ACTION DENYING REZONE REQUEST

RE: Request for rezoning of a ± 105.23-acre tract of land located on south side of Rocky Branch Road in the 1331st G.M.D., Oconee County, Georgia, (tax parcel numbers (TAX PARCEL numbers B-03-025 & B-03-025A) from A-1 (Agricultural) to R-1 (Single-Family Residential).

**Planning Department
Oconee County, Georgia
STAFF REPORT**

REZONE CASE #: 7428

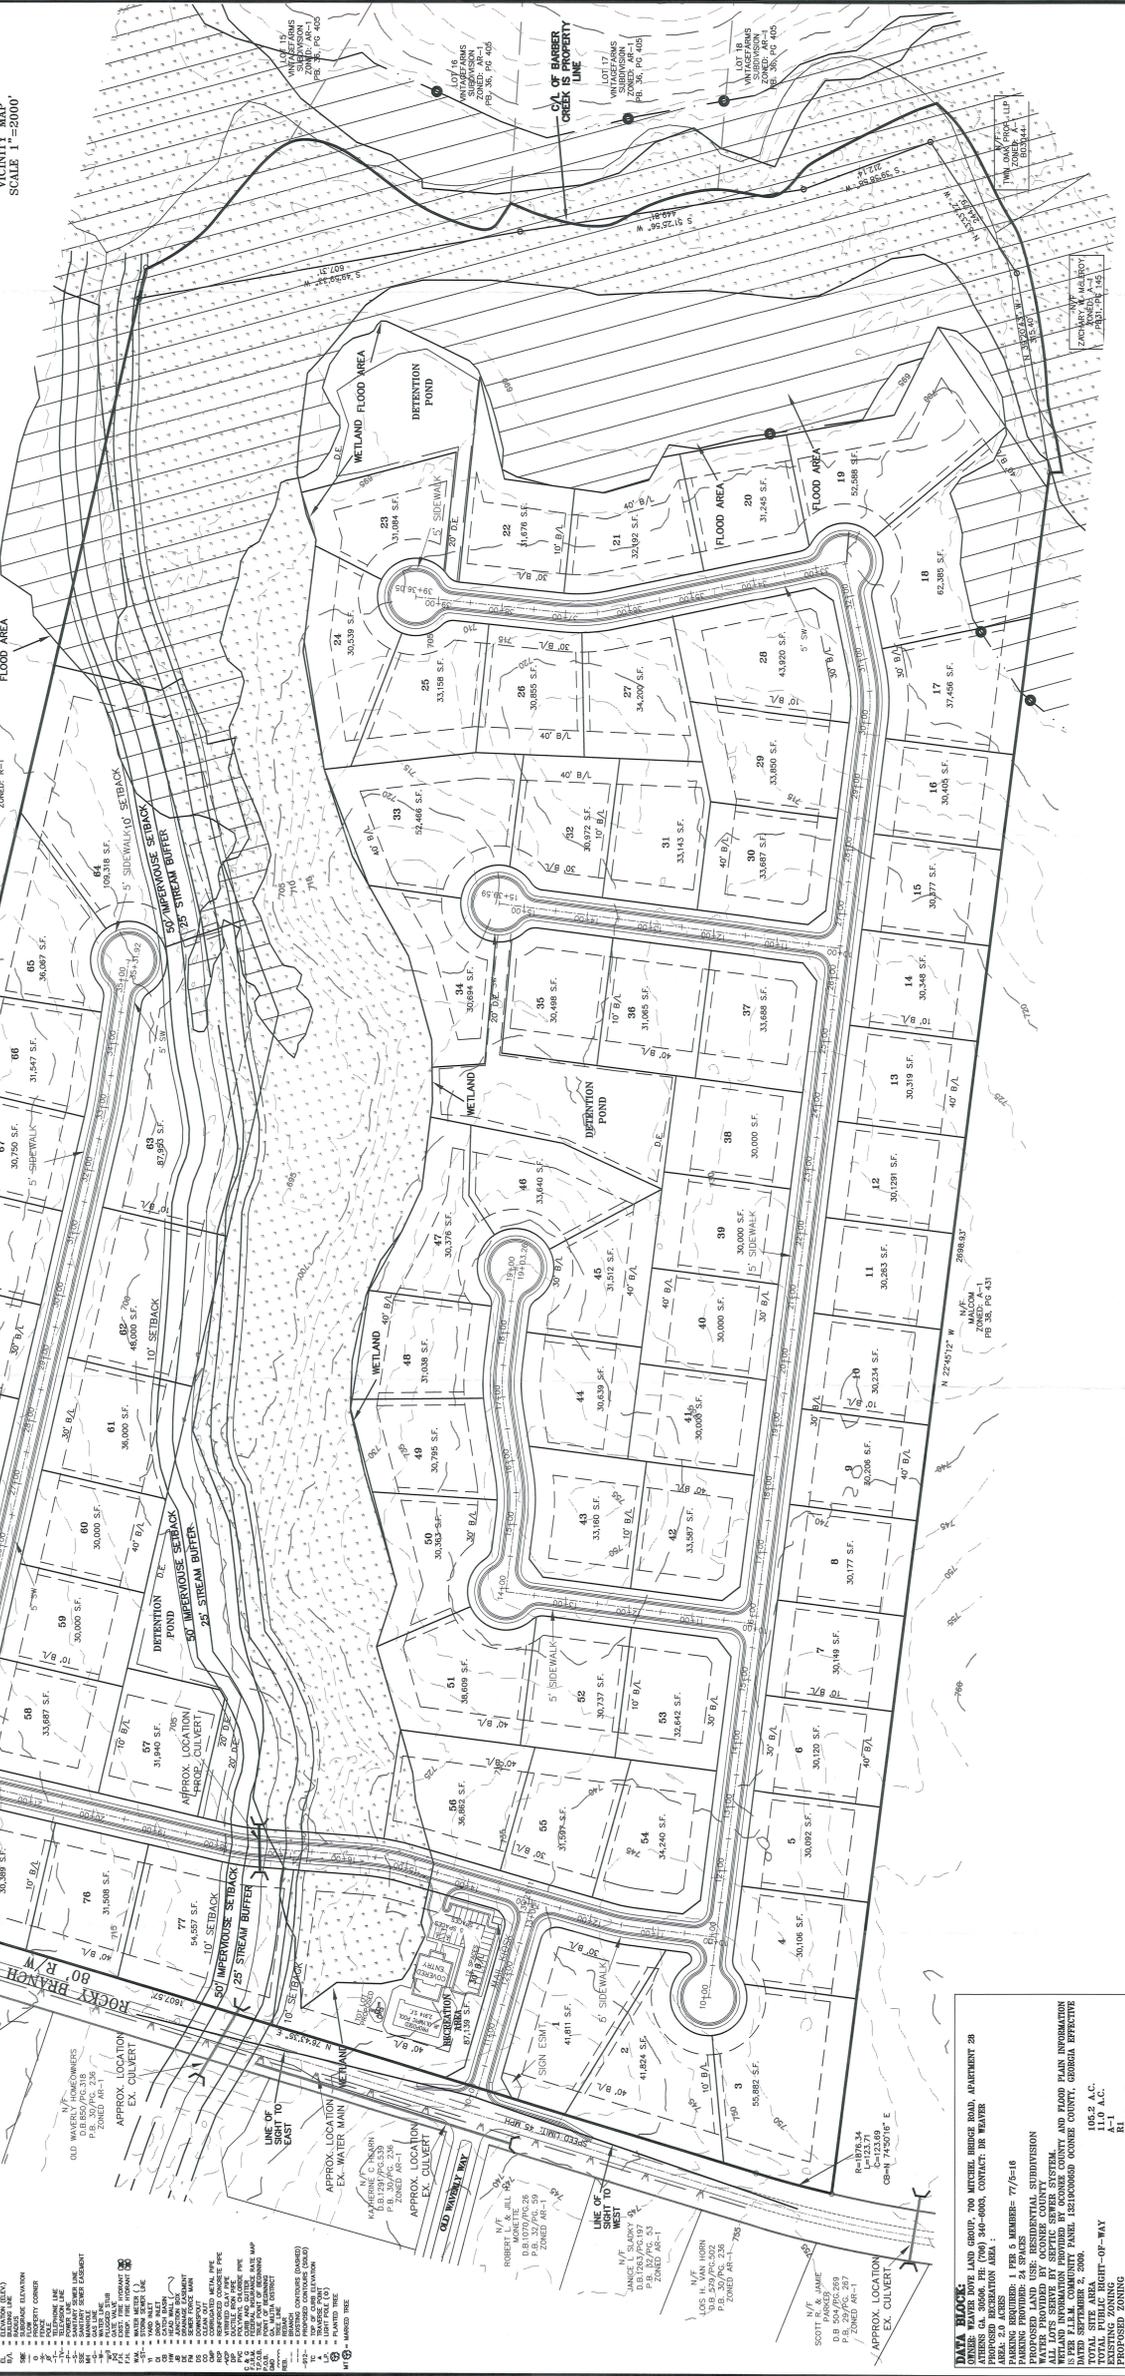
- Provide street names, pavement widths, and right-of-way widths. Include cul-de-sac dimensions. These items can be addressed upon submittal of the Preliminary Plat.

- Prior to submittal of the Preliminary Plat, verify if a center left-turn lane is required on Rocky Branch Road. This needs to be done in accordance with Oconee County standards.

- Clarify how the CBU (mail kiosk) will be accessed. Public Works prefers that it be accessed from the proposed recreation area parking lot and not the proposed public street.

- Provide a one-foot no-access easement along any lot (including the amenity area) that has frontage along Rocky Branch Road.
- Regarding the drainage easement near lot 57 and a proposed detention area, verify whether or not this easement will be ditched. If ditched, Public Works suggests that the easement be routed in a fashion so as to remove the 90-degree turn.

- Please address the non-compliant [UDC Section 1008.04 (f) (2)] street that extends from lot 64 to 74 exceeding 1000 feet in length without a proposed turn around.

- J. Is the site suitable for the proposed use relative to the requirements set forth in the Unified Development Code (off-street parking, setbacks, buffer zones, open space, etc.)?** There are a number of lots depicted on the attached concept plan lying within primary conservation areas that may have to be eliminated or reconfigured to provide for the minimum buildable area required by UDC Table 4.1. Additionally, the Oconee County Health Department has indicated that larger lot sizes will likely be required to meet the minimum area of usable soils required by the same Department for lots with private septic tanks and drain fields. In view of the foregoing, staff believes that the subject site is not suitable for a development of the proposed density.
